CERTIFICATE OF APPROPRIATENESS

Property: 2111 Del Monte Drive, Lot 17, Block 44, River Oaks Section 3 Subdivision. The property includes a historic 4,316 square foot two-story, Georgian Revival residence situated on a 10,501 square foot (75' x 150) interior lot.

Proposal: Alteration – Windows. A COA was approved in May 2016 for to shutter two windows and construct a third floor rear addition. The applicant is now proposing the following revisions:

EXISTING – YELLOW WINDOWS ARE TO BE REPLACED

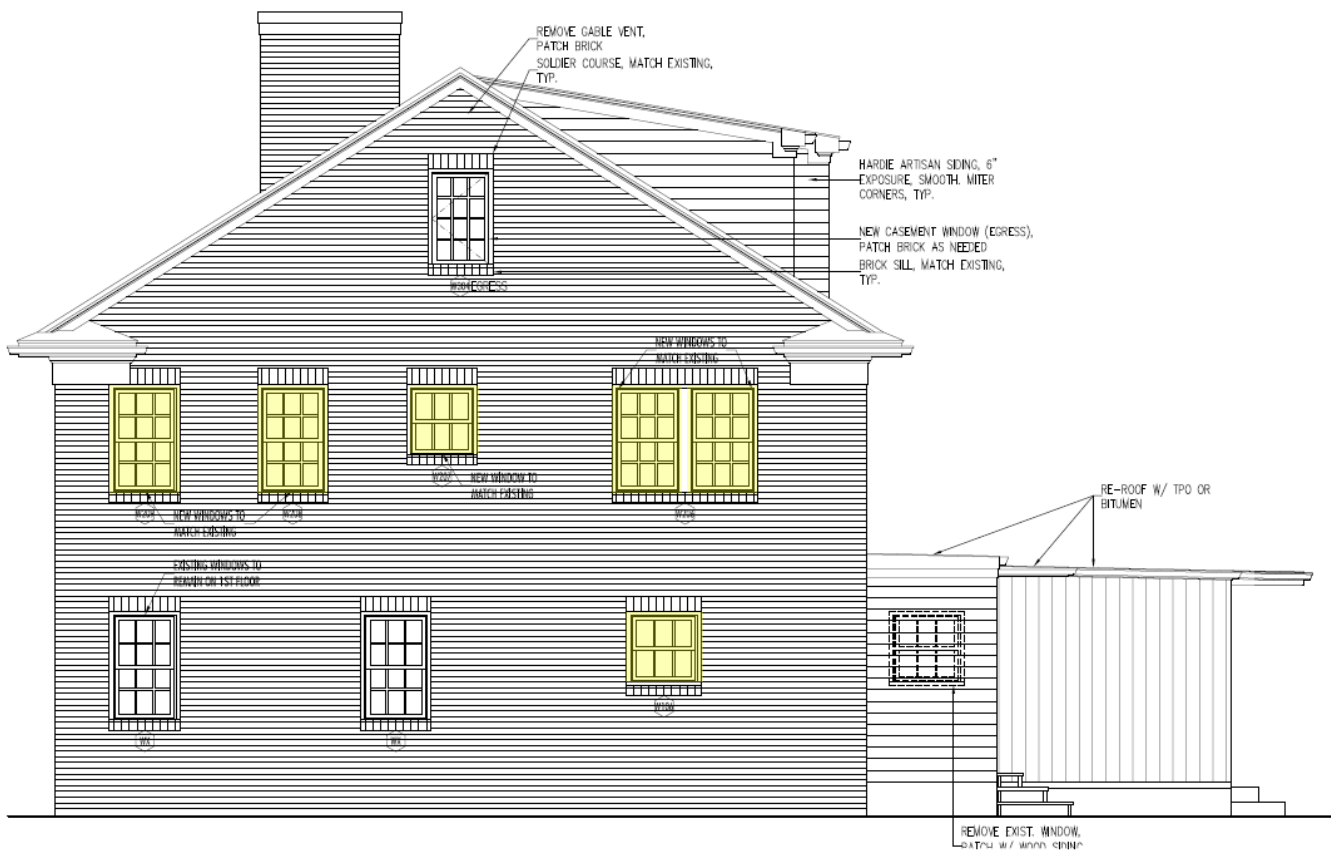
- Remove nine 6-over-6 and one 3-over-3 original windows on the sides of the structure. Replace with new wood windows to match existing.
- Remove two original 4'-6" x 2'-6" openings on the first floor. Create a new, 9' x 6'-8" opening and install three full length, multi-lite French windows, the middle will be operable while the side windows will be fixed.

<i>The removal of original windows and openings in favor of a new fenestration pattern does not preserve the character of the building. Enlarging openings to accommodate the new French windows will destroy historic material as well as alter the distinguishing character of the building.</i> |

<i>Removal of original windows from elevations visible from the public right of way and replacement with new material is inappropriate. The use of salvaged wood windows from the rear of the house to replace any visible windows that are damaged beyond repair would be an appropriate remedy.</i> |

Recommendation: Approval with conditions: Restore and retain any operable window. Approval to replace windows W201, W202, W203, W204, W205, W206, W207, W208, W209 with salvaged windows from the rear of the structure.

FIRST FLOOR PLAN

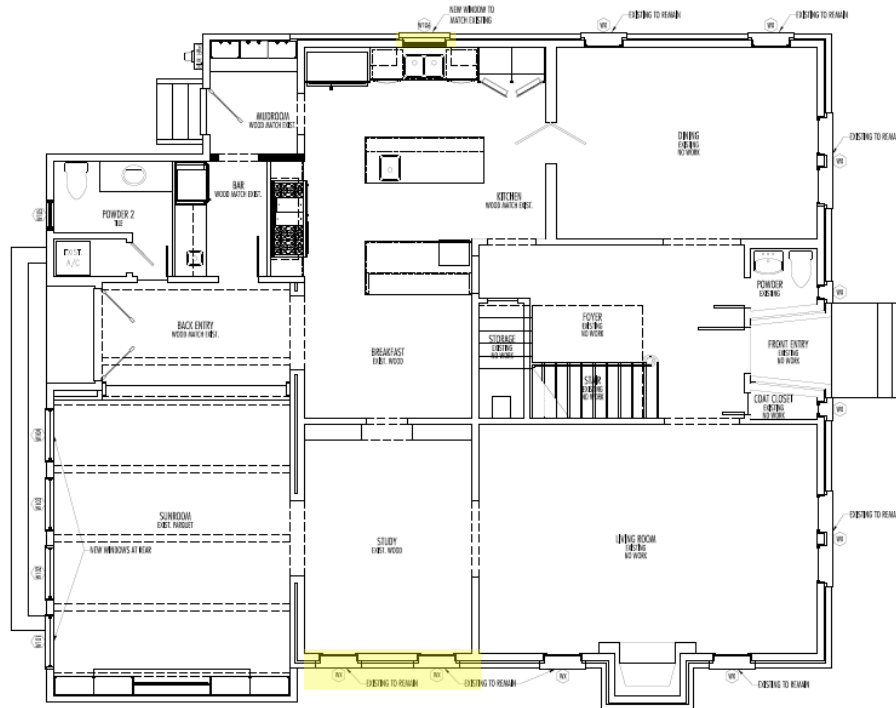
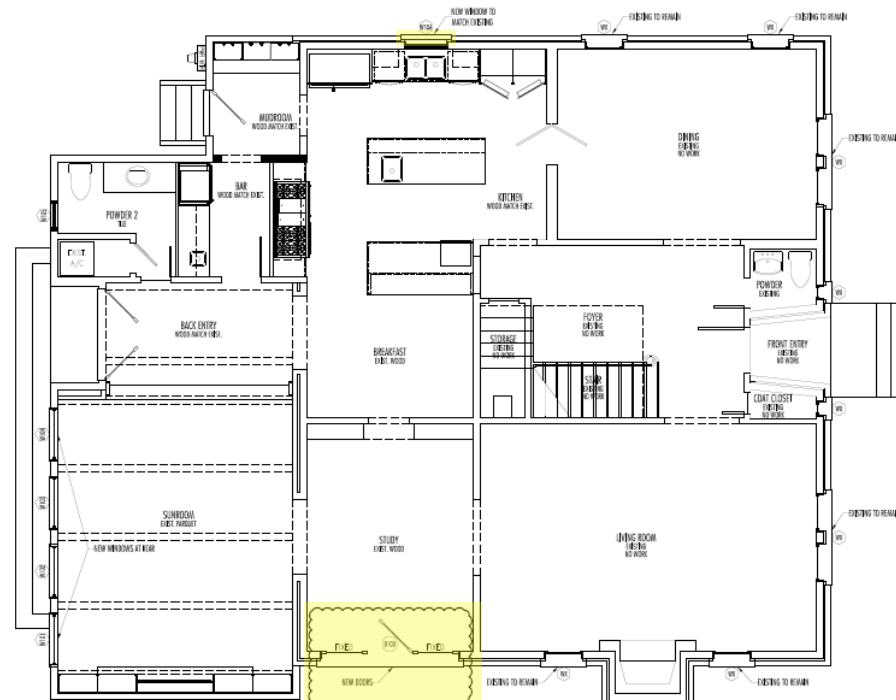
<i>The proposed removal of two original windows and openings in favor of a larger opening will permanently alter the form and destroy the historic integrity of the building.</i> |

Side Elevation: The applicant proposes to remove two original windows and openings at the rear of the first floor and install two new windows and a French door, all require new openings. The applicant also proposes to replace two original windows towards the front of the elevation on the second story. See drawings for more detail.
(East)

SECOND FLOOR PLAN

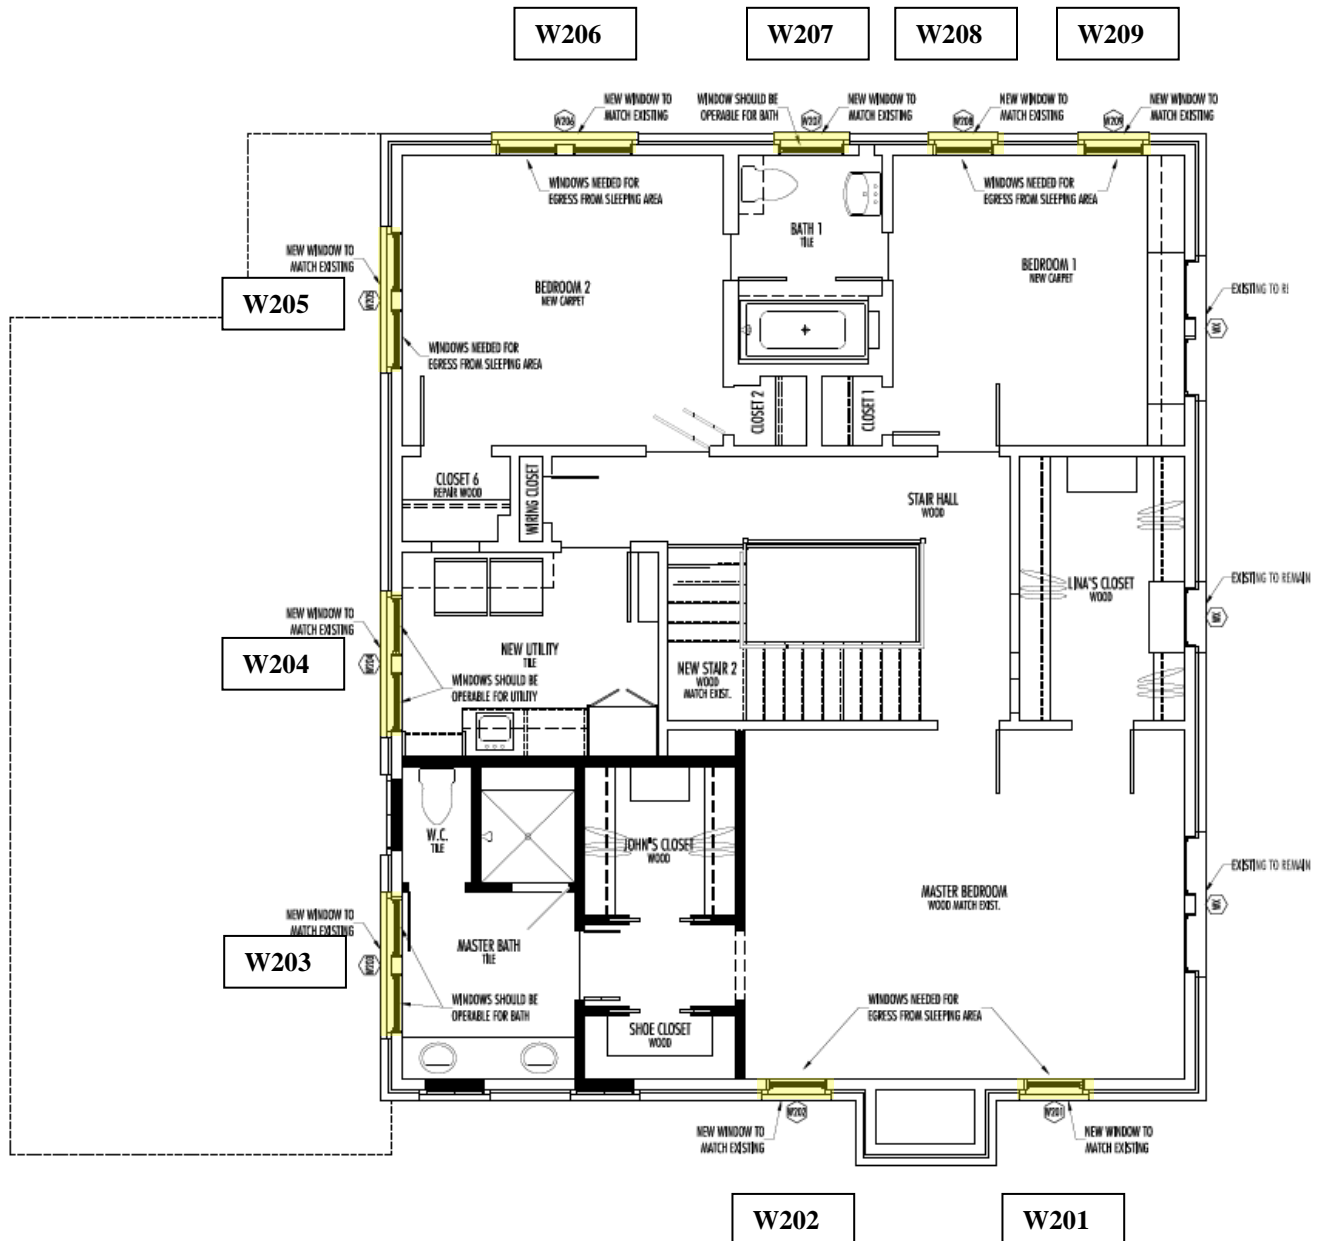
Window W206: Sill damaged due to rot

Window W206: Sash damaged due to dry rot

Window W208: Paint lifted from sash due to improper AC conditions

Window W209: Paint lifted from sash due to improper AC conditions
